Recall Campaign

NHTSA#: 17V-561

TC#: 2017-440

CHANGING THE FEDERAL CERTIFICATION LABEL AND TIRE LABEL

FRONT RIGHT OFF DOOR SIDE (ODS)

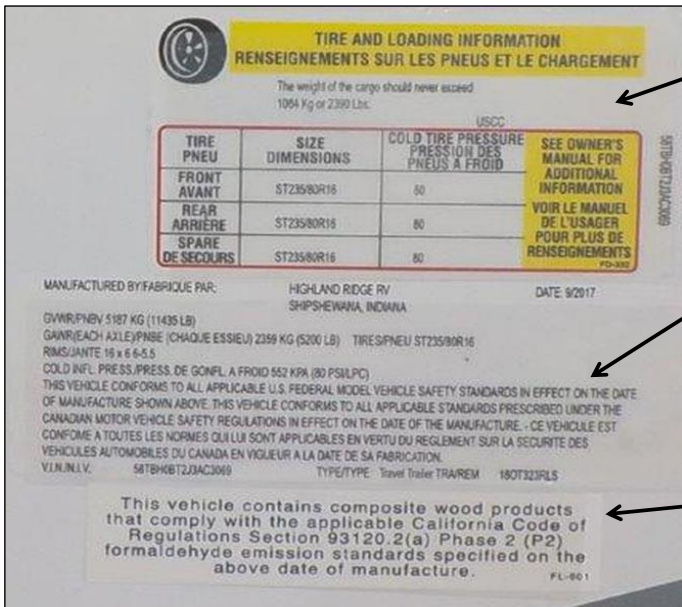
Replace Tire and Federal Labels due to incorrect tire size noted as 235/80R16 when **correct size tires on unit are 235/85R16**
Complete and return the RECALL REPLY FORM

Place the Tire Pressure label above the Federal Certification label
(Do NOT cover the Federal Certification label)

Place the Federal Certification label under the Tire Pressure label

Do NOT cover up the Formaldehyde Label when placing the new labels
